# W-3598 Richard Hoit Jones Revocable Trust (Grey Briar) (Special Use Rezoning from RS9 to RM5-S)

Project Name: W-3598 Richard Hoit Jones Revocable Trust  
(Grey Briar) (Special Use Rezoning from RS9 to RM5-S)  
Jurisdiction: City of Winston-Salem  
ProjectID: 1105235

Thursday, September 21, 2023

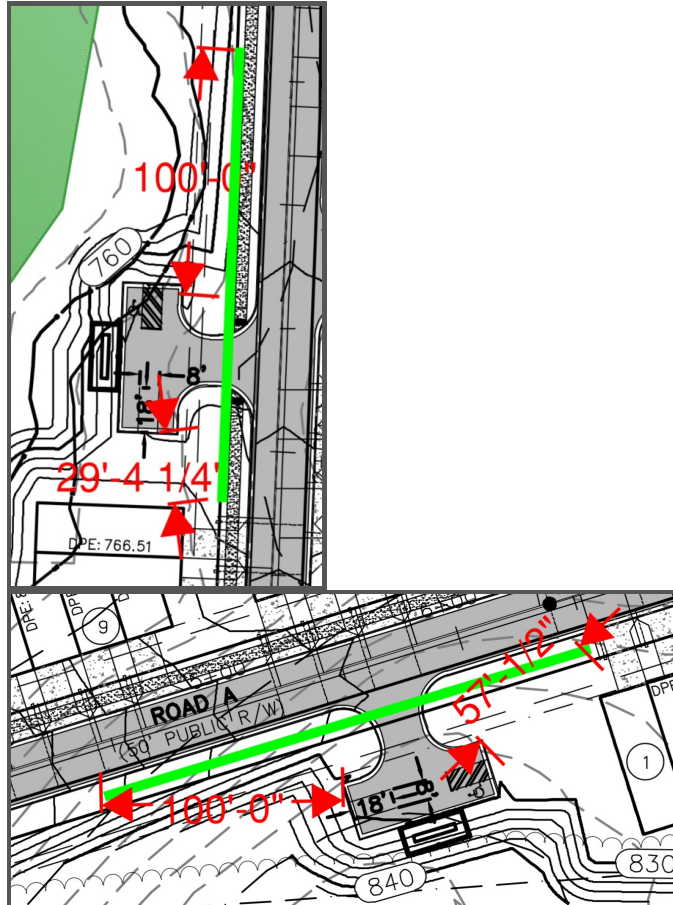
- There can be no residential parking spaces off of public streets. Multifamily, commercial, and industrial properties may provide parking along private roads and private access easements, absent other restrictions.
- All parking maneuvers must occur in the off-site area or structure.
- Site plans must show a five-foot wide unobstructed paved pedestrian walkway between the principal building main entrance and each sidewalk-designated public street.
  - **"?These provisions shall not apply in the RSQ, RM-5, RM-8, RM-12, RM-18, RM-U, or MH districts where there are individual driveways or garages adjacent to each unit."**

#### Size of Planting Areas

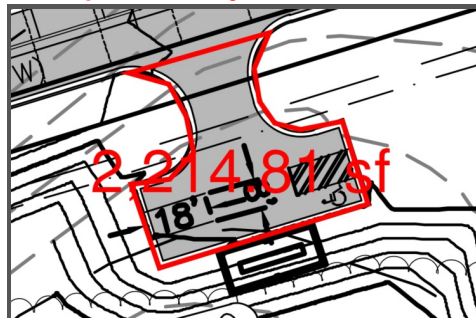
- Each planting area shall allocate a minimum of one hundred fifty (150) square feet per tree.
- Each planting area shall allocate a minimum of six hundred (600) square feet for each large variety tree.
- Each planting area shall allocate a minimum radius of seven (7) feet for each small or medium variety tree.
- Each large variety tree planted shall provide a seven hundred fifty (750) square foot credit towards the requirements of Section 6.2.1C, Tree Preservation and Planting.

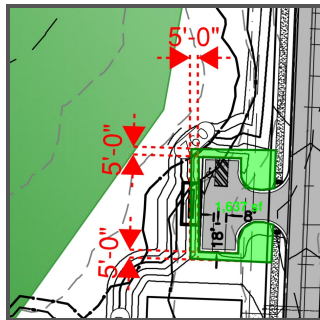
- **Planting areas shall be at least five (5) feet wide, unless otherwise approved by the Director of Planning and Development Services, or a designer?**

- **After allocating the 5' width requirement for Planting Areas, your northern visitor's lot has a planting area of approximately 1,637 sqft. This will require two (2) large variety trees (600 sqft requirement x2 = 1,200 sqft of planting area coverage) and five (5) small trees & twenty (20) shrubs (100 sqft requirement x5 = 500 sqft of planting area coverage). In this way, your approximately 1,637 sqft of planting area can be covered by 1,700 sqft of planting area coverage. You will need to do a similar calculation for the southern visitor's lot.**
